CONSTRUCTION SUMMARY

Lindsay 2017 Developments Inc. / Sugarwood

Lot/Unit: 40 Phase/Building: 2 Model/Floor Plan: Cavendish Lake (4210) Elev B 4Bed 4.5Bath

SKETCH #1

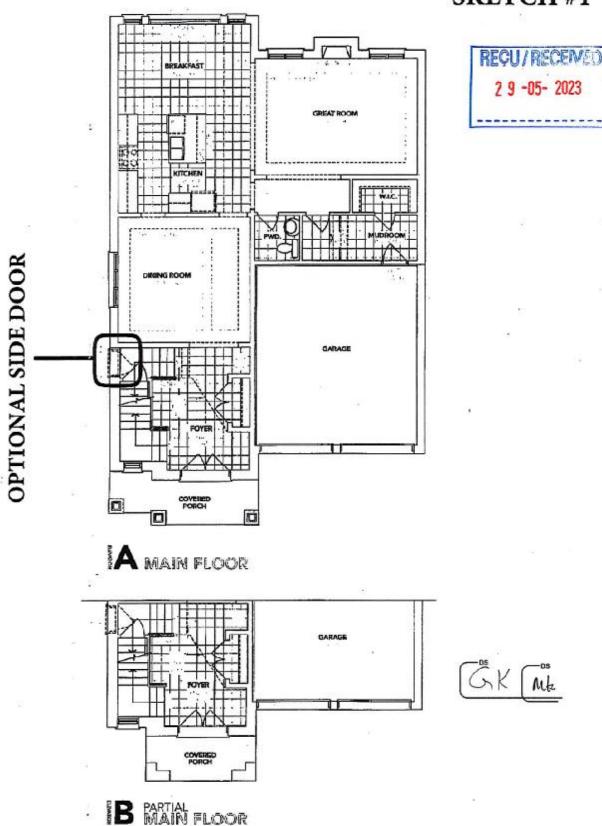
Inv. 6259	1 - TO SUPPLY AND INSTALL THE OPTIONAL SIDE DOOR SEE SKETCH #1	
Line 79093	Note:	
26May23 / 26May2	3	
PLUMBIN	G	
Inv. 6259	1 - TO SUPPLY AND INSTALL THE OPTONAL 3-PC ROUGH-IN INTHE BASEMENT SEE SKETCH #2	
1
